## Humboldt Bay Municipal Water District 12 kV Switchgear Relocation Project Bid Addendum #1

The purpose of this Addendum is to modify the Contract Documents for the subject project. This Addendum shall become part of said Contract Documents.

This Addendum addresses the following items and questions:

Client	<b>HUMBOLDT BAY MUNICIPAL WATER DISTRICT</b>	
Project	<b>12 kV SWITCHGEAR RELOCATION</b>	
Title	<b>CIVIL SITE PLAN</b>	
Project No.	11186675	
Original Size	ANSI D	
Sheet No.	<b>C-101</b>	
Sheet	3 of 24

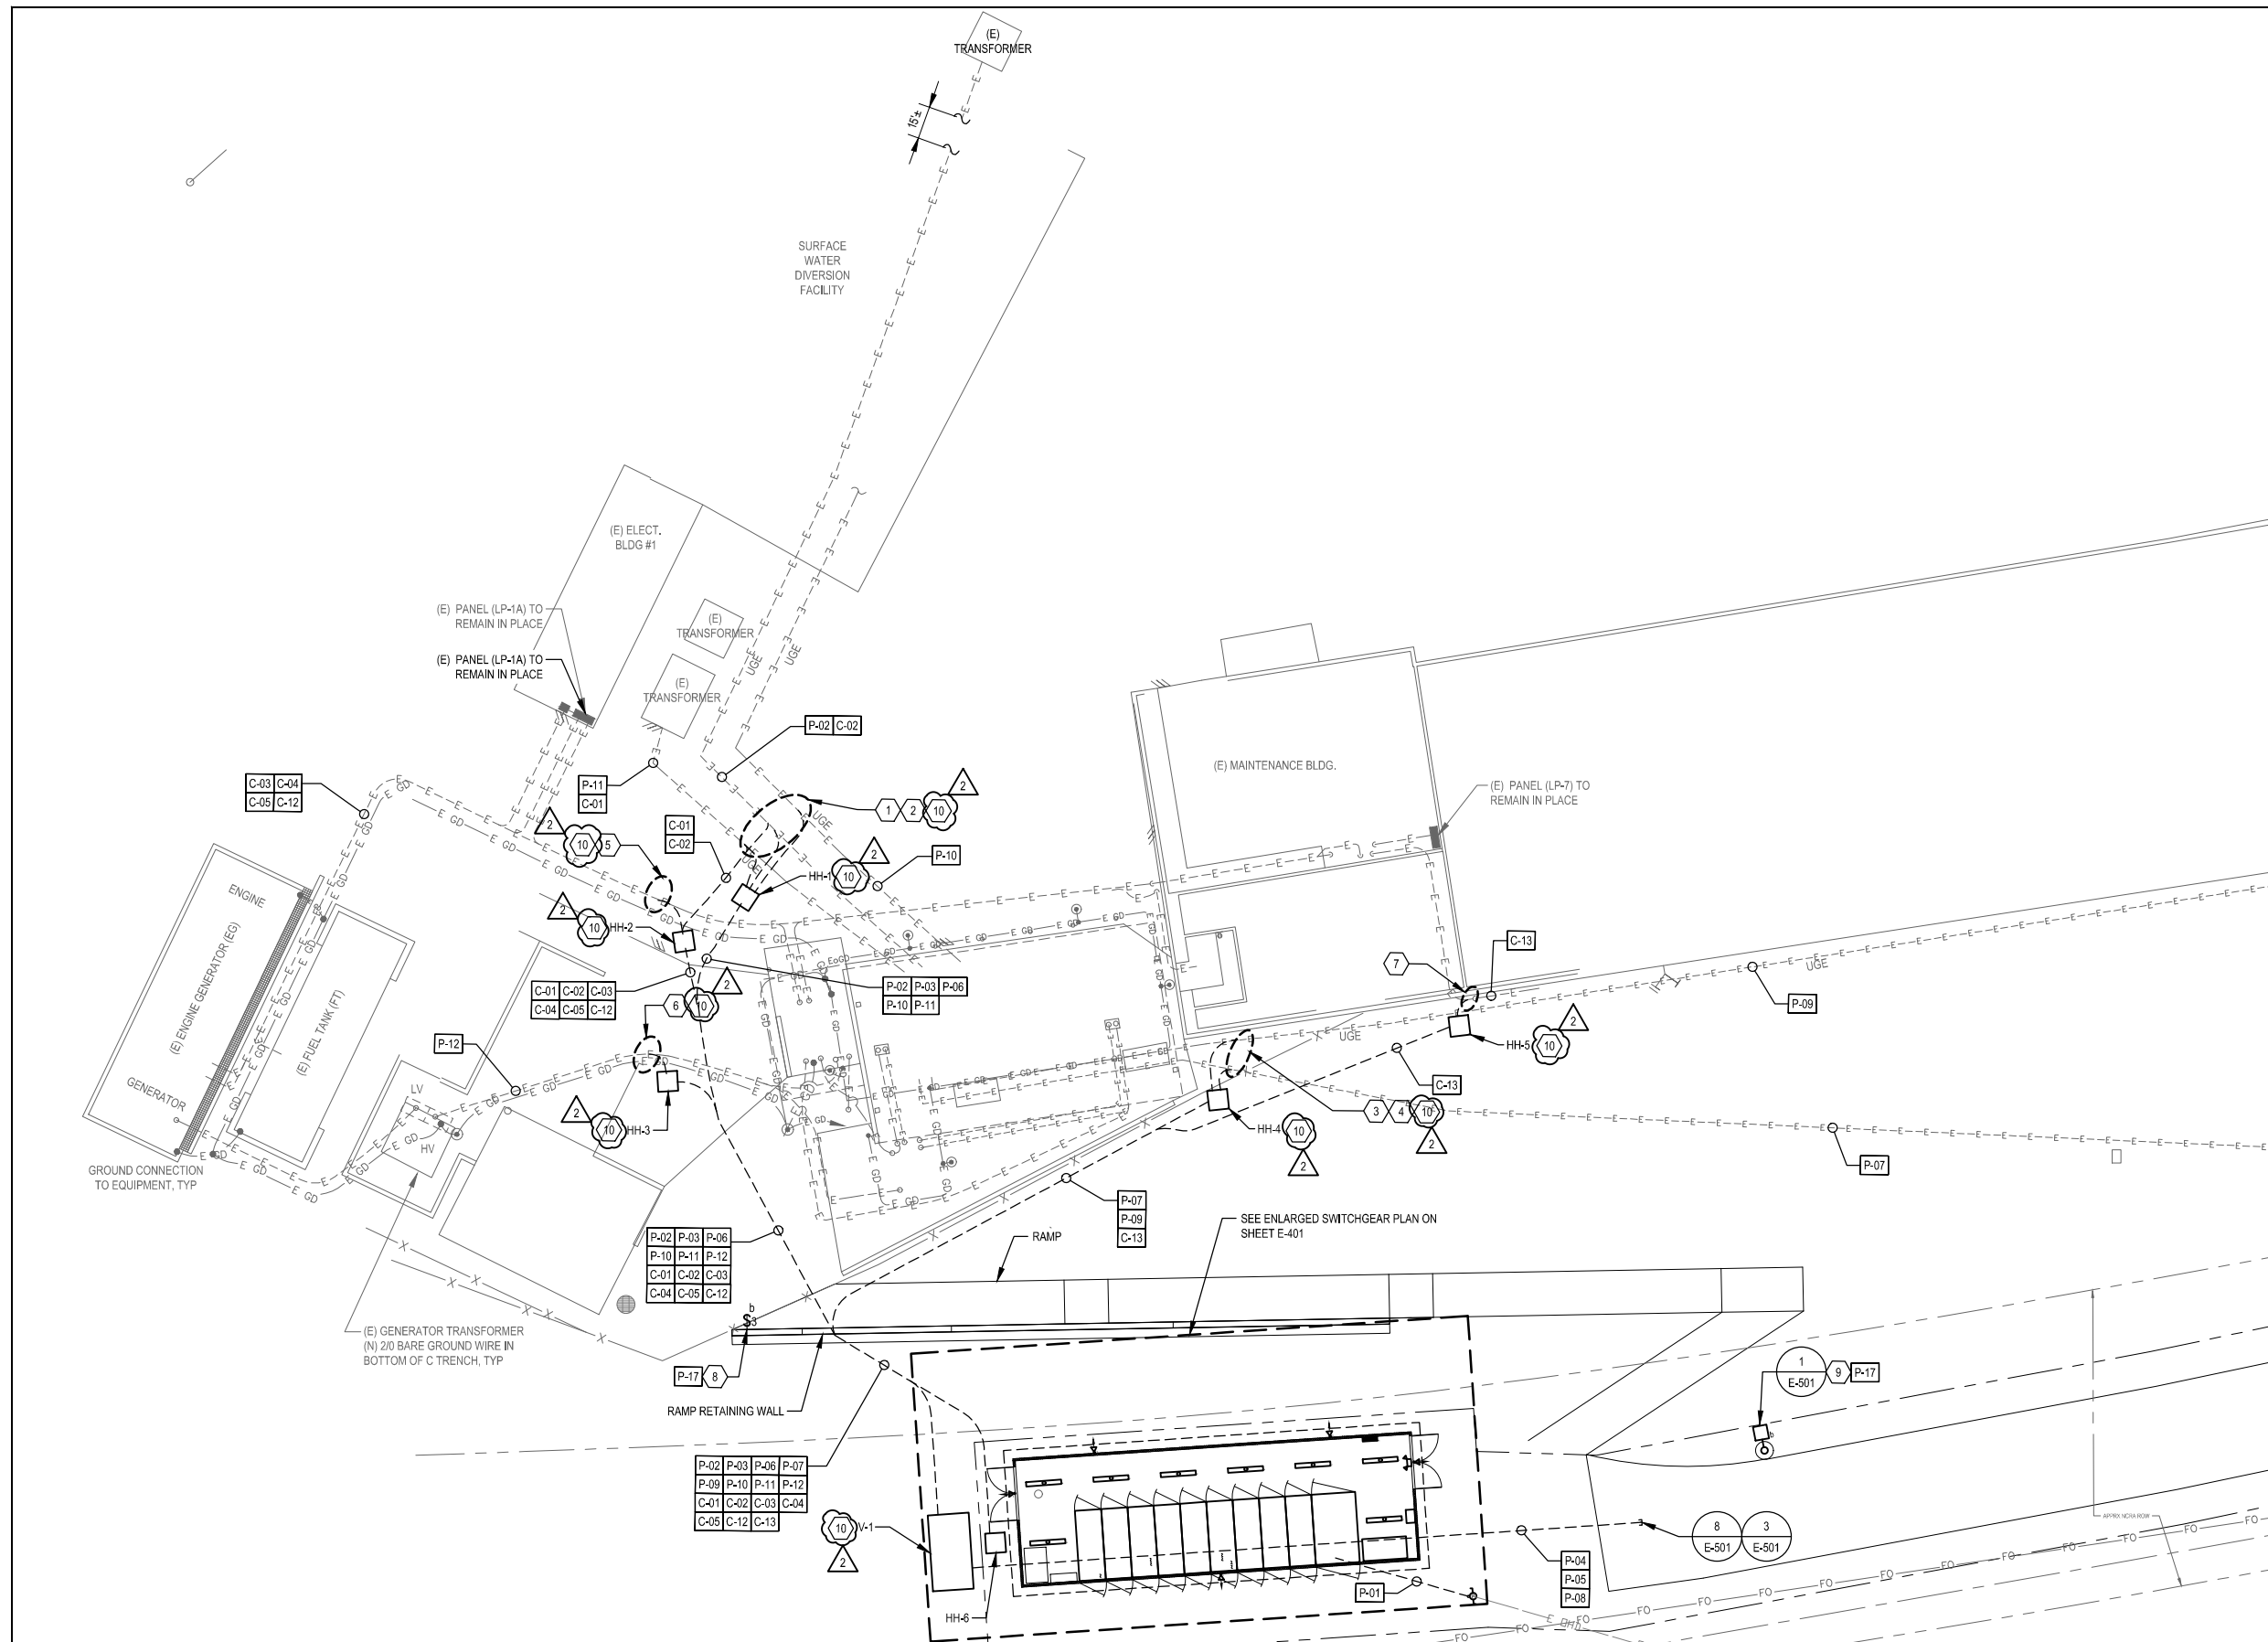
- i) Hot-dip galvanized.
26. Sheet C-101 indicates the existing DI at the west side of the project (Sheet Keynote #7), and it appears that there is not an existing grate at this location. Is the Contractor to include furnishing and placement of a new grate for this item?

28. Sheet C-101, Keynote 4 states "(E) switchgear facilities to be demolished per Sheet ED-101." This shall be replaced with "(E) switchgear facilities to be demolished per Sheet E-101", as shown in the attached revised C-101.

- i) The existing structure called out by Keynote #7 on Sheet C-101 is a storm drain manhole and does not currently have a grate. It is not intended that a new grate shall be furnished and placed at this location. The new drain lines will tie in to this existing storm drain manhole. A separate new DI and grate will be installed as shown by Keynote 2 on Sheet C-101.

Client	<b>HUMBOLDT BAY MUNICIPAL WATER DISTRICT</b>		
Project	<b>12 kV SWITCHGEAR RELOCATION</b>		
Title	<b>SINGLE LINE DIAGRAM - NEW</b>		
Project No.	11186675		
Original Size	ANSI D		
Sheet No.	<b>E-602</b>		
Sheet	16 of 24

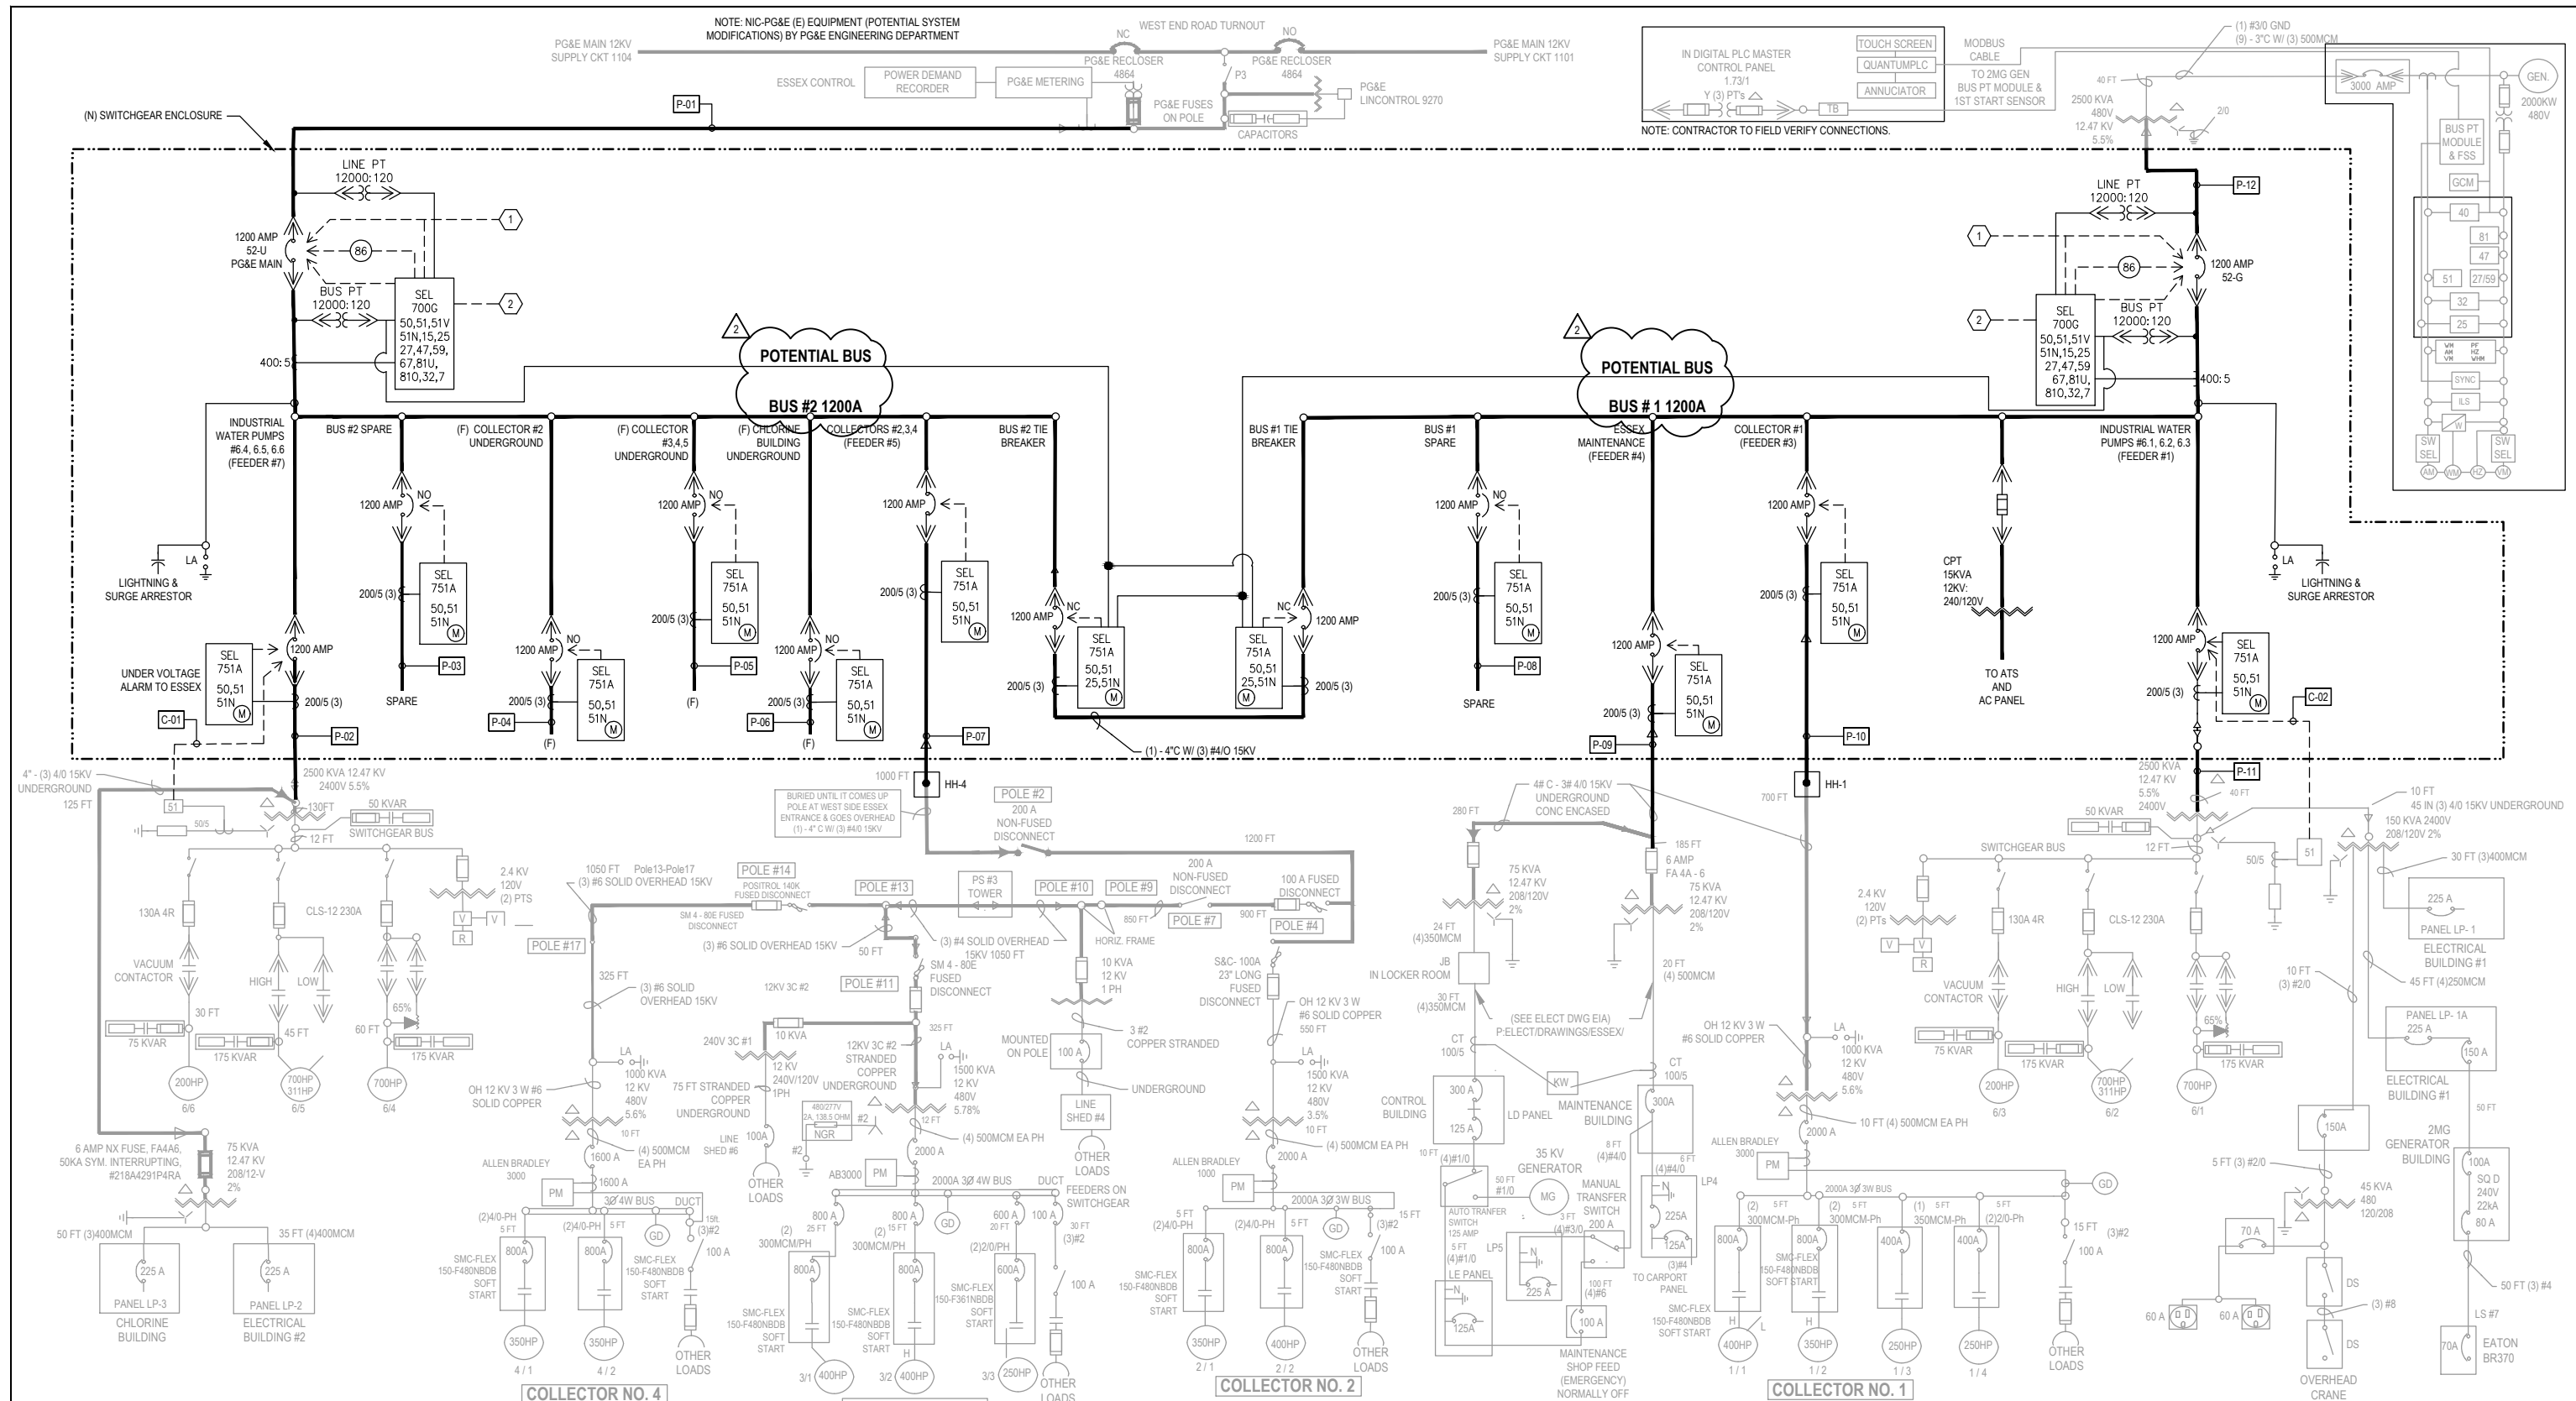
16. What is the cable connection between SEL protective relays between the bus tie relays?
  - i) The cable connection between SEL protective relays is the potential bus. This is shown on the attached revised E-602.
